Groundwater Transfer Review Summary Form

Transfer/PA # I- <u>14/14</u>
GW Reviewer <u>Byron Ebner and Grayson Fish</u> Date Review Completed: <u>8/22/2025</u>
Summary of Same Source Review:
☐ The proposed change in point of appropriation is not within the same aquifer as per OAR 690-380-2110(2).
Summary of Water Level Decline Condition Review:
☐ Water levels at the original point(s) of appropriation have exceeded the allowed decline threshold defined by conditions in the originating water right.
Summary of Injury Review:
\Box The proposed transfer will result in another, existing water right not receiving previously available water to which it is legally entitled or result in significant interference with a surface water source as pe 690-380-0100(3).
Summary of GW-SW Transfer Similarity Review:
\Box The proposed SW-GW transfer doesn't meet the definition of "similarly" as per OAR 690-380-2130.
This is only a summary. Documentation is attached and should be read thoroughly to understand the

Transfer Application: T-14714

Application Map

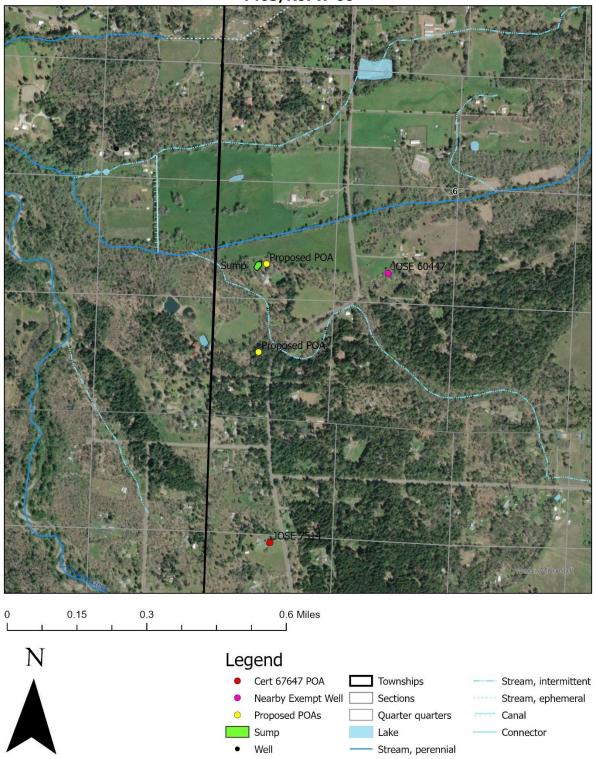
6.	a) Will this proposed change, at its maximum allowed rate of use, likely result in an increase in interference with another surface water source ?
	⊠ Yes □ No Comments: POAs are moving further away from Democrat Gulch. The
	authorized POA is 240 ft from Democrat Gulch while Proposed POAs are 295 ft and 1055 ft from Democrat Gulch. The proposed POAs are moving further from Democrat Gulch, which will likely result in no change or a decrease in interference.
	JOSE 60711 is 65 ft closer to Althouse Creek compared to the Authorized POD (2180 vs 2115 ft). The reduction in distance between the proposed POA 1 and Althouse Creek is likely to result in an increase in interference with that surface water source.

b) If yes, at its maximum allowed rate of use, what is the expected change in degree of interference with any surface water sources resulting from the proposed change?
	Stream: Althouse Creek
	Stream:
	Provide context for minimal/significant impact: Given the relatively minor change in distance of the proposed POA compared to the authorized sump's location, the expected increase in interference with Althouse Creek is likely to be minimal.

8.	What conditions or other changes in the application are necessary to address any potential issues identified above:
9.	Any additional comments: <u>TL 1701 has 3 additional ponds separate from the current</u> authorized sump. Additionally, JOSE 58981 is very close to the sump and has been

constructed since 7/2012.
